Appendix 2: Internal and External Consultee Representations

<p>Carbon Management Team</p>	<p>Carbon Management Response 21/12/2021</p> <p>In preparing this consultation response, we have reviewed:</p> <ul style="list-style-type: none"> • Energy and Sustainability Statement (Parts 1-3) prepared by (dated October 2021) • Outline Whole Life Carbon Report, prepared by Buro Happold (dated October 2021) • Detailed Whole Life Carbon Report Plot A, prepared by Buro Happold (dated October 2021) • Outline Circular Economy Statement, prepared by Buro Happold (dated October 2021) • Detailed Circular Economy Statement, prepared by Buro Happold (dated October 2021) • GLA carbon emission reporting spreadsheet • Relevant supporting documents. <p>1. Summary</p> <p>The development achieves a reduction of 44% carbon dioxide emissions on site overall, which is supported in principle. This will be achieved primarily through a connection to the Decentralised Energy Network.</p> <p>The detailed element of the hybrid application (Plot A) is proposed to reduce emissions by 91% overall, which is supported in principle. However, this plot does not fully comply with Policy SI2(B), which will need to be addre

Image 1: GLA Heat Risk Map for Tottenham Haringey (dark red is highest risk)

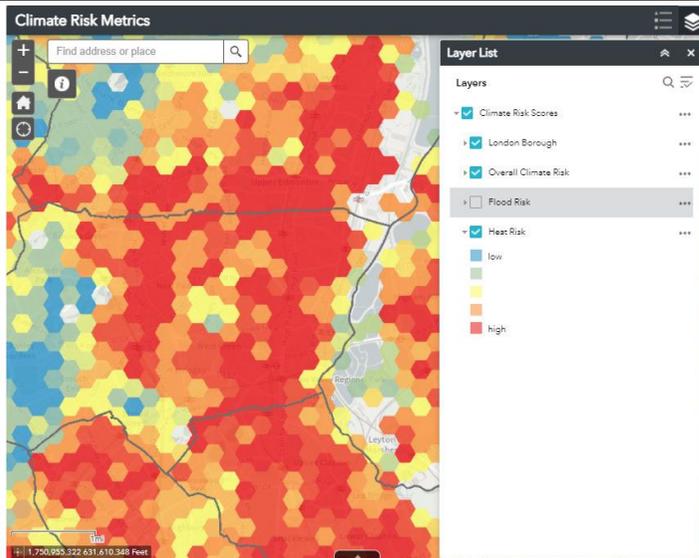
- As outlined during pre-application discussions, the model needs to be redone with London Weather Centre data (not Heathrow) to represent the urban heat island effect. Further justification was also included in the emails dated 29th October, demonstrating that Tottenham (and this area in particular) suffers from 'high heat risk', which is the highest level of risk, on the GLA Climate Risk Metrics map (screenshot added below – ref Image 1). In addition:
